**Subject:** Improvement of the performance map of the new IAE50R-AA ECU with serial numbers "AE00XXX" which were installed as standard from 2014 onwards.

**Applicability:**

**Classification:** Minor Change

**Fig. 1: Affected ECU version**

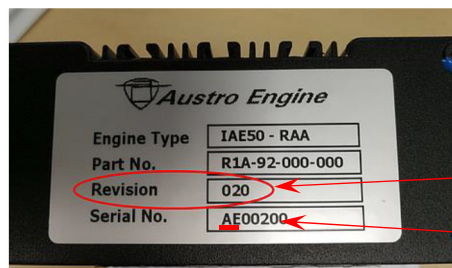
The revision is 020 (or even AA1)

The serial number starts with AE

**Fig. 2: Change of the revision number after the update**

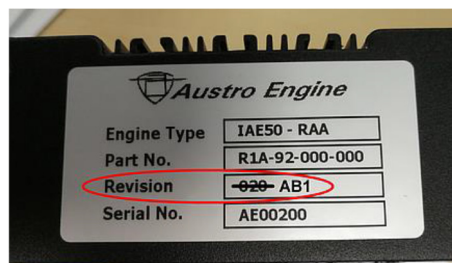
With removed or easy accessible ECU affix a new identification plate onto the original one or carry out the change with a wipe-resistant marker (permanent marker).

**Fig. 3: Identification of the ECU at ASH 30 Mi und ASG 32 Mi.**

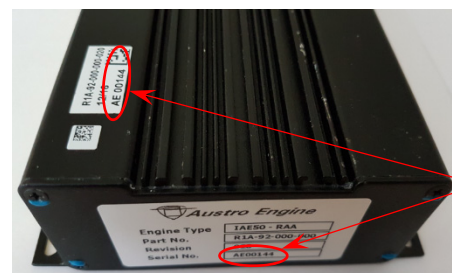
It takes some effort to remove and reinstall the ECU. For identification of the ECU's serial number, it is also possible to use the label that is visible when installed, see Fig. 3. If the ECU is reprogrammed in the installed state and the revision of the ECU's identification plate is not accessible, an alternative replacement plate (see Fig. 4) is attached to the accessible side of the ECU. If this ECU is removed or replaced later, this replacement plate has to be removed and the revision changed on the original identification plate as described above.

When installed the serial number of the affected ECU's can be checked on the upper label too.
